MEMORANDUM

TO: W. Krats FROM: P. M. Pettigrew
SUBJECT: PROBLEMS ASSOCIATED WITH DATE: March 1, 1973
INTERPRETATION OF ZONES 1-3

Sketch showing relationship of suggested zone 2 grid to revised zones 1 & 3 grid
 Note northward shift of transverse sections south of #122 due to error in original grid.

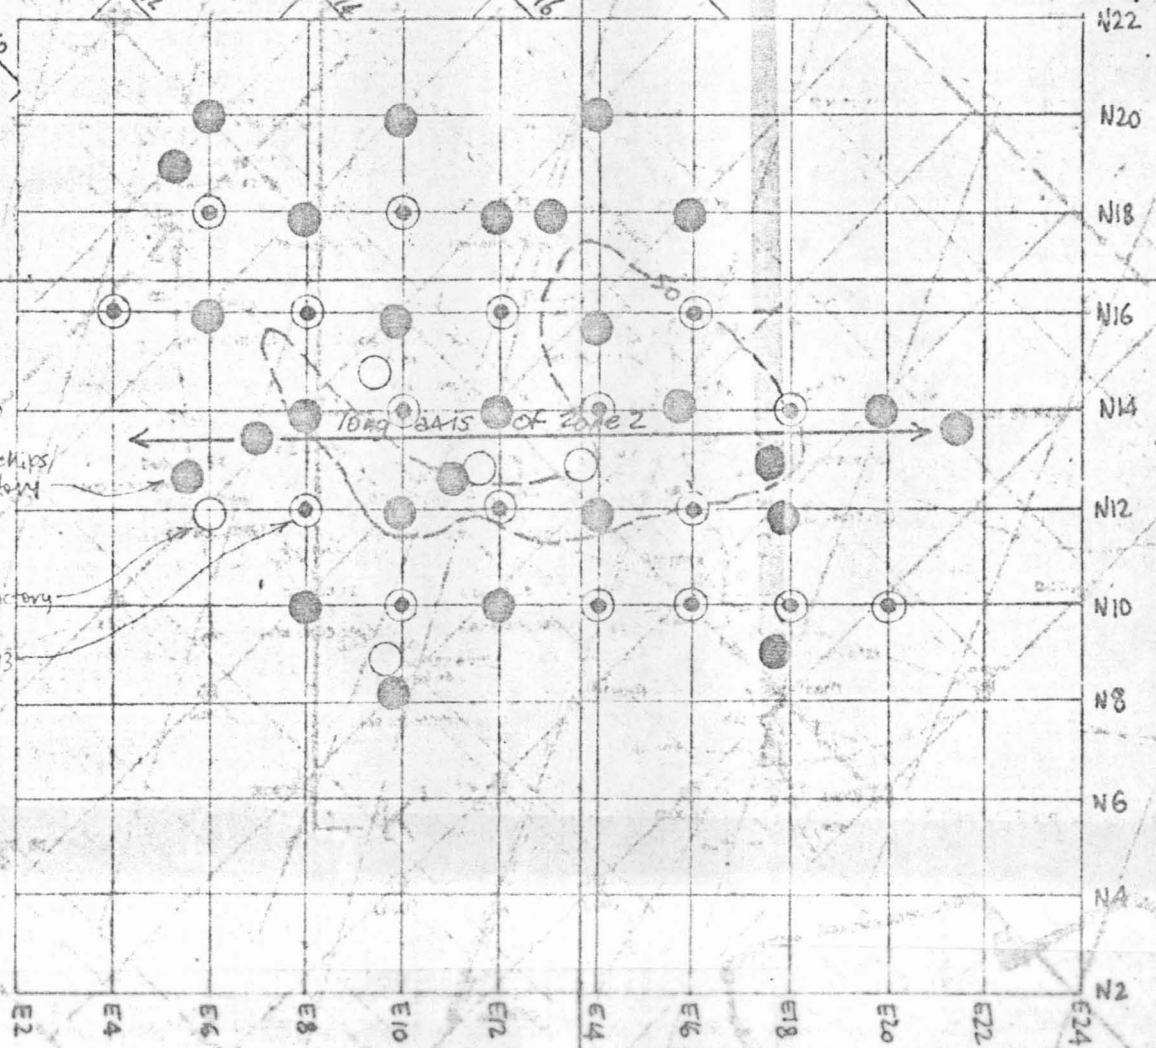
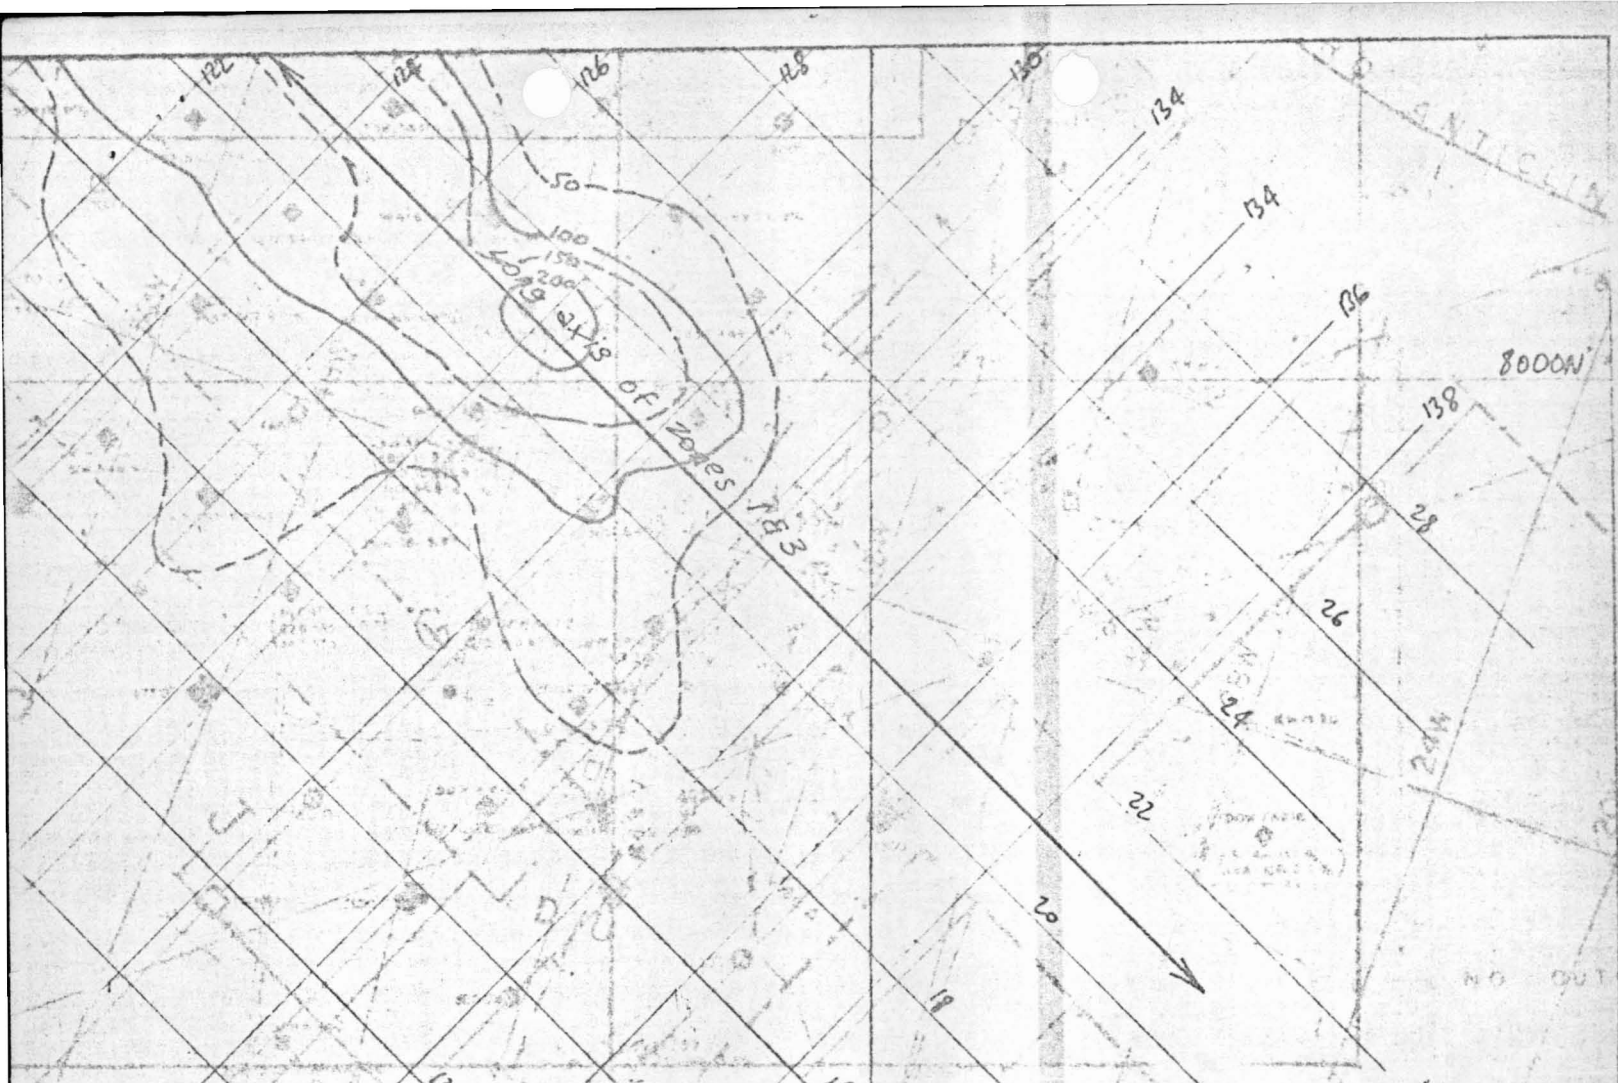
(iii) In Zone 2, the Zones 1 and 3 cross-sectional grid has been forced to fit what is, in fact, a unit of quite different orientation. A NS, EW (200 ft. square) grid is recommended. Attached are copies of the present and recommended grids.
